# Review of Interconnected Highway-Rail Grade Crossing

**DOT# 012203N**

**Prepared by Benesch for  
BNSF Railway**

January 8, 2024

**TRAFFIC SIGNAL TABLES**

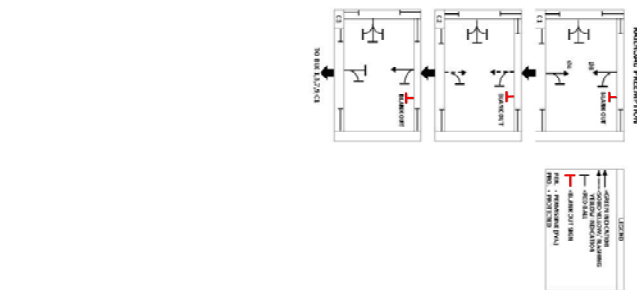
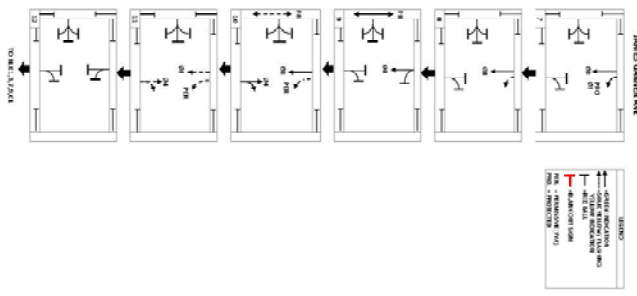
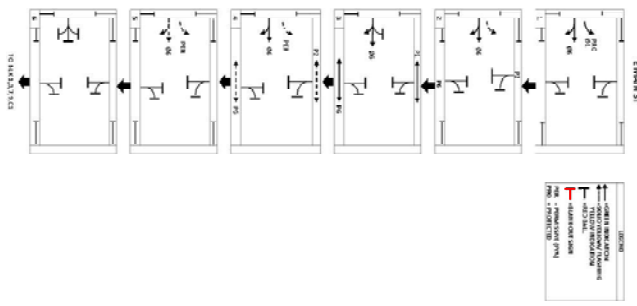
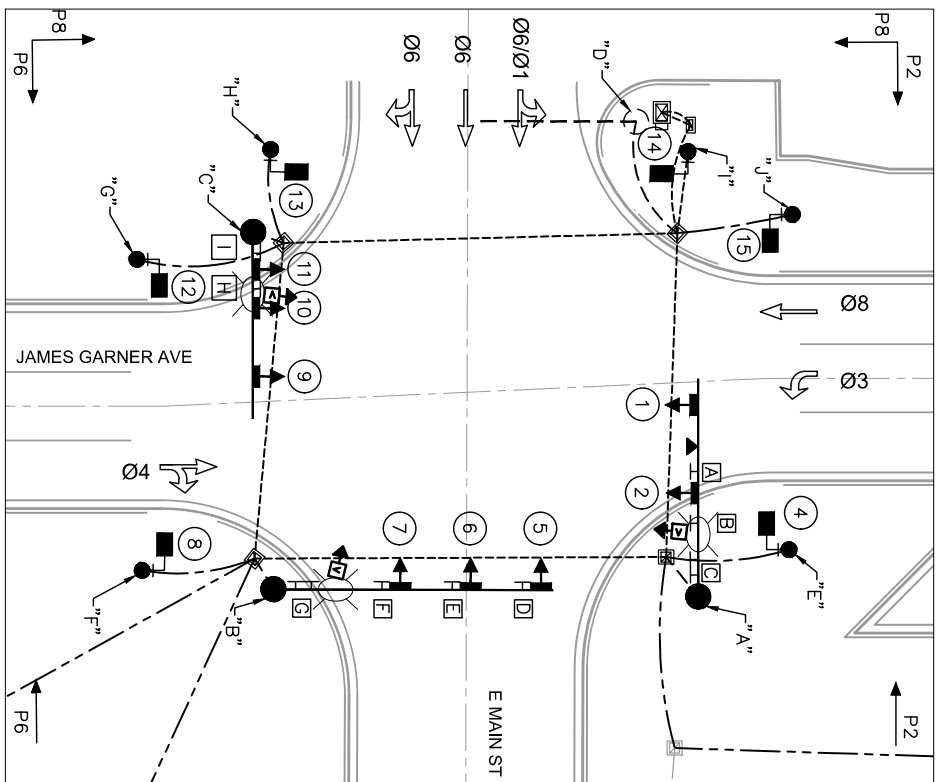
2.	Consider adding backup power supply	MUTCD	Battery backup added to plans.	Complete
3.	Restrict right turns toward the grade crossing during preemption per MUTCD (options include turn restriction blank-out sign or traffic signal head and signage with exclusive right turn arrow indications).	MUTCD	Added turn restriction blank-out signs.	Complete

**TRAFFIC SIGNAL WIRING DIAGRAM**

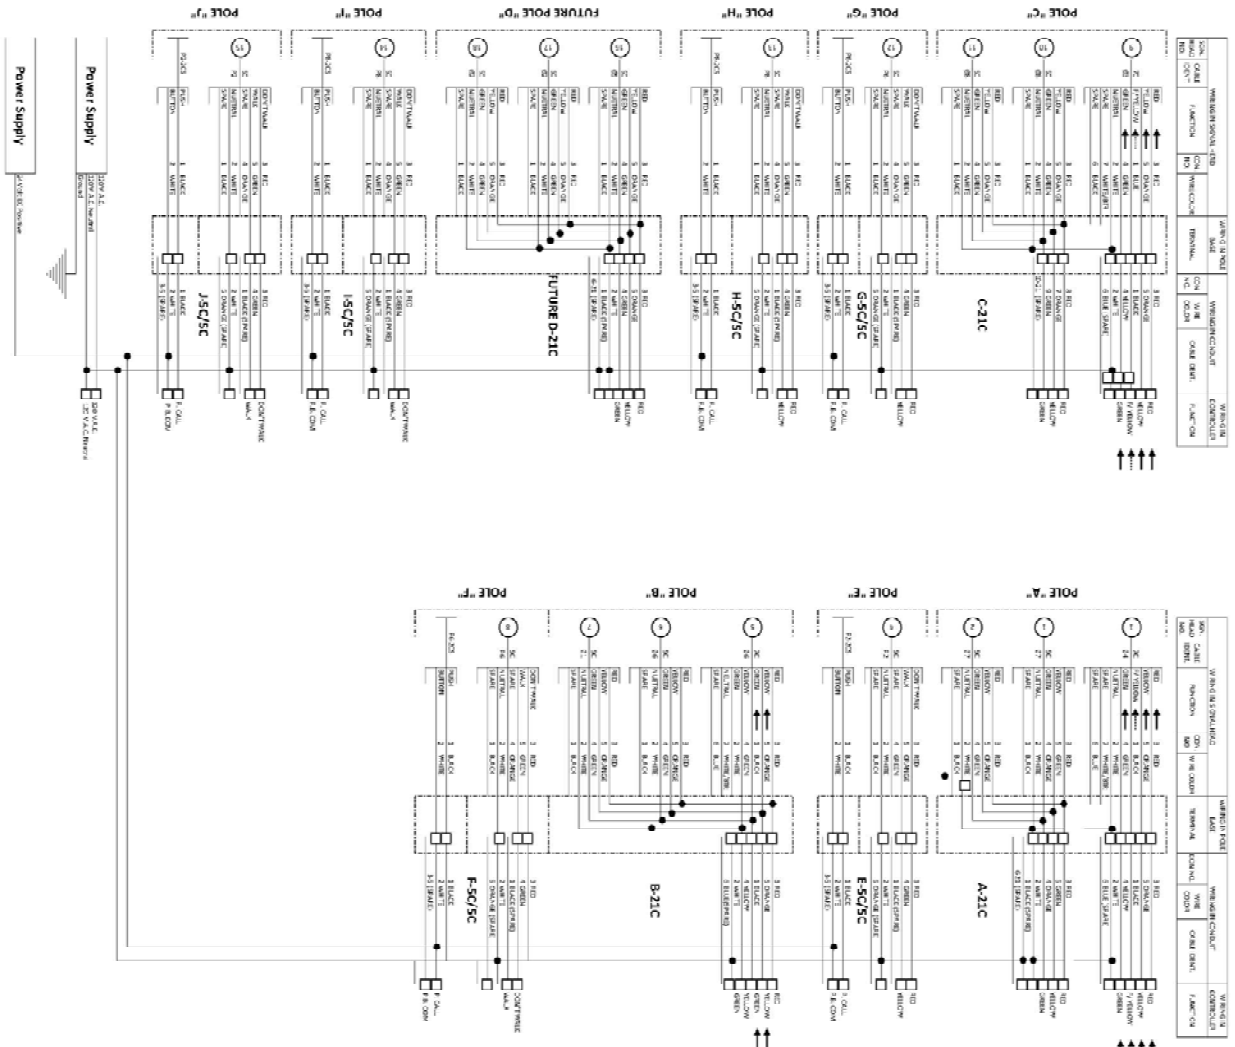
No.	Benesch Recommendations	Standard/ Reference	Agency Response	Benesch Response
<b>James Garner Ave Street Improvements - dated 8/22/2022</b>				
1.	Include railroad interconnection run and cabling details. Identify the proposed interconnection circuits and interface method to be used. Note: voltage provided to interconnection circuits shall not exceed 28 VDC. Indicate voltage on plans.	BNSF Design Standard	Notes and wiring diagram added to plans.	Complete

5.	Agency is responsible for all conduit, pull boxes and interconnection cable. Show conduit and cable run from traffic signal cabinet to Railroad house. Preemption cabling should be one continuous pull. BNSF requests interconnect cabling be coiled in a pull box nearest the final run to the railroad house with adequate cabling to make the final pull. Contact BNSF for right of entry requirements. If boring under the track is necessary, coordinate with BNSF.	Industry Best Practice BNSF Standard	Added note to plans.	Complete
